SB TMG 691-1004 P1

# SERVICE BULLETIN

**Service Bulletin No. / Date:** SB TMG 691-1004 P1, Initial Issue / March 02, 2017

**Subject:** Water separator

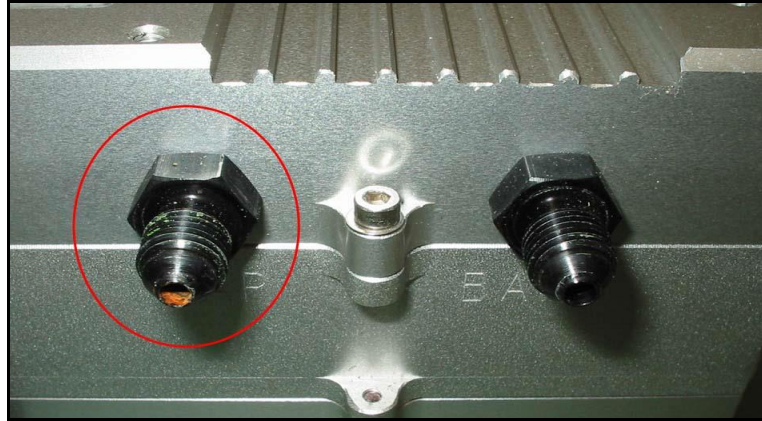
- Remove both MAP lines to check the FADEC fittings.
- Inspect the FADEC fittings for water, water residues, corrosion, sediments etc. Refer to the picture below.

**If such damages are detected, the FADEC needs to be replaced.**

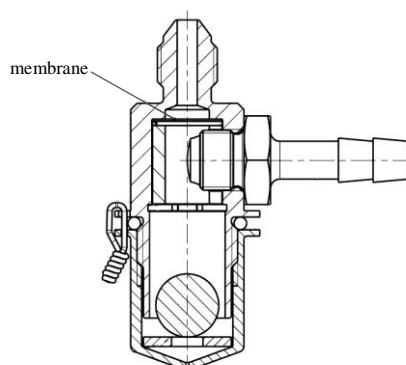
- Remove the pilot seat i.a.w. the original A/C AMM.
- Check if an original water separator system is installed.  
See figure below.

- If no original water separator system is installed carry out Diamond Service Bulletin RSB D4-104/1 or later issue.
  - If an original water separator system i.a.w. RSB D4-083 is installed carry out Diamond Service Bulletin RSB D4-083/1 or MSB D4-104/1 (*resp. later issues of both*).  
Alternatively, install the water separators P/N 50-3940-E0020 03 (DAI P/N: D60-9076-14-01) according to section 4 "Water Separator Installation".
- ◆ Note: If the FADEC D48 has been replaced by a FADEC D4 please also take into account Diamond Service Bulletin OSB D4-098/1.
